## **Tri-Tech Medical Outlet**

No. 99-0416

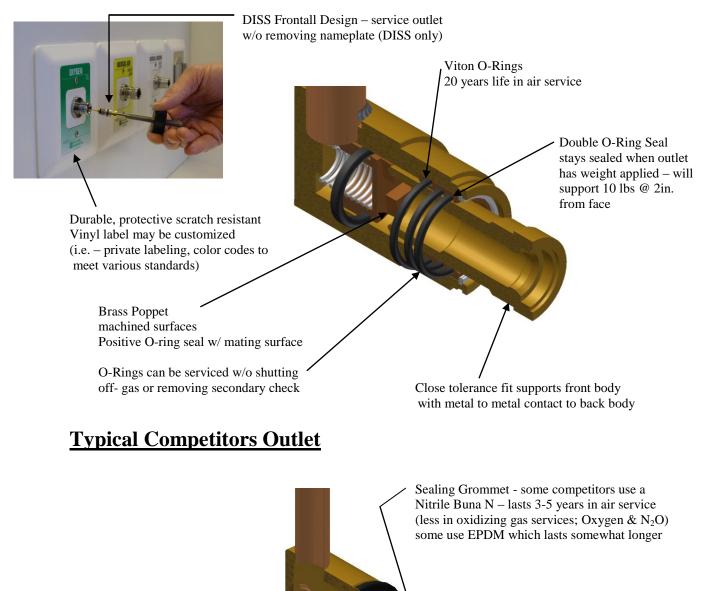
Grommet <u>deforms</u> and <u>leaks</u> when weight is applied to outlet

Plastic Poppet — Plastic surface seals against rubber grommet

Front body is <u>NOT</u> supported with metal to metal contact deforming grommet and causing <u>LEAKS</u>

To service grommet – gas must be shut off and all parts removed
